SERVICE BULLETIN

M1450: Milwaukee-Eight Equipped Vehicles - Loss of Power or High Engine Braking

2018-08-21

M1450

Figure 1. Cam Support Plate Tightening Sequence

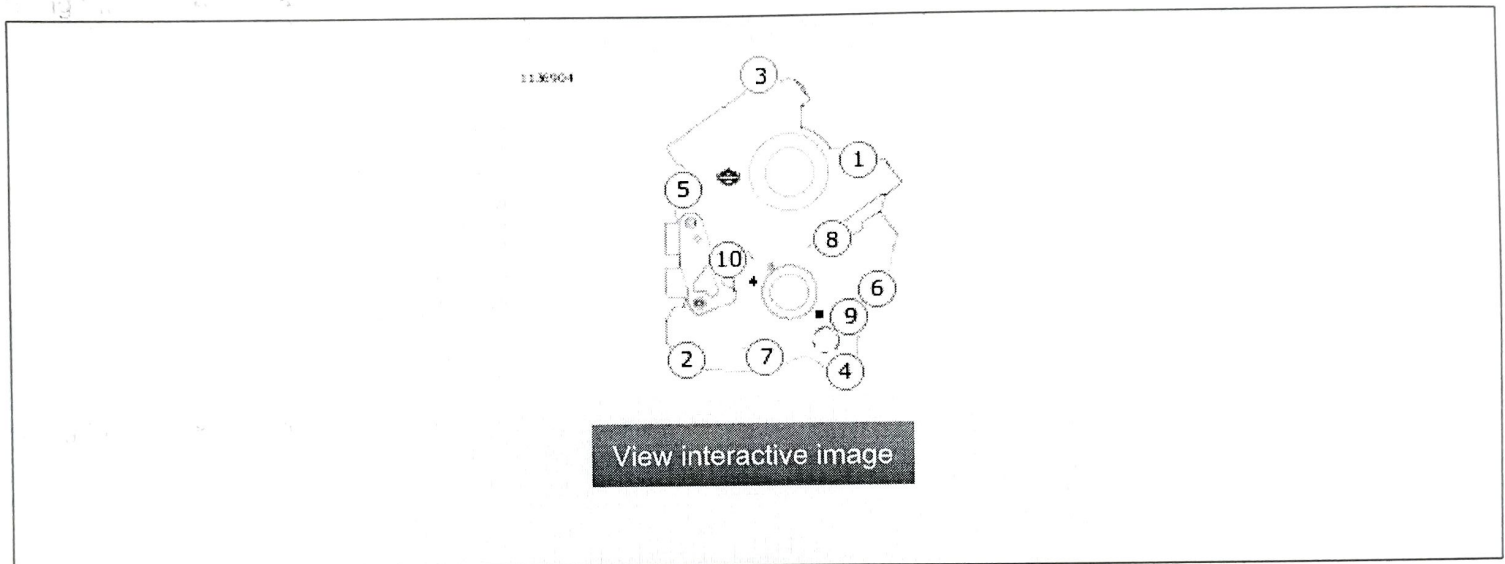
1. Install cam support plate. See the service manual.
2. [Refer to Figure 1.](#) Follow modified tightening sequence.

- a. Tighten screws 1-6.
- b. Rotate crankshaft 360°.
- c. Tighten screws 7-10.

Torque: 10.4–12.7 N·m (92–112 in-lbs)
